TOWN OF HART FORD
COUNTY OF WINDSOR
U.S. ROUTE 5 (MAJOR COLLECTOR)
HARTFORD VERMONT

PRECAST ELEVATIONS & SECTIONS

PC-5

SECTION
1"= 1'-0"

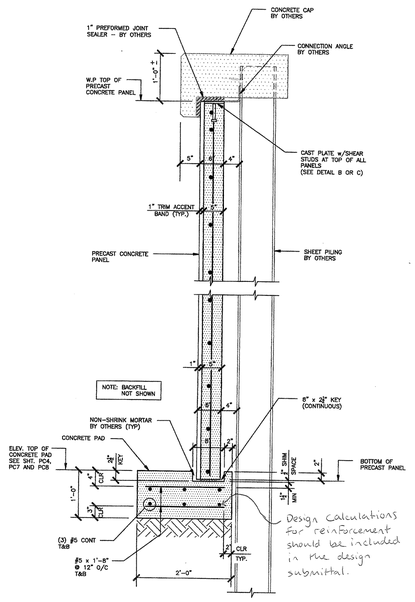
Design calculations for reinforcement should be included in the design submittal.

TYPICAL PRECAST PLANK REINFORCING ELEVATION
N.T.S.

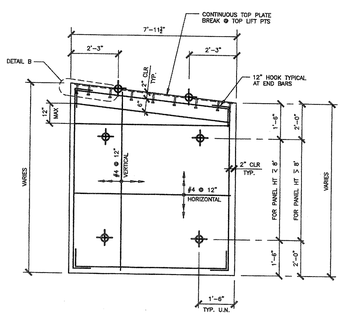
*Specify 4-ton inserts for Worcester Ave. Panels weighing more than 5,700 lbs.
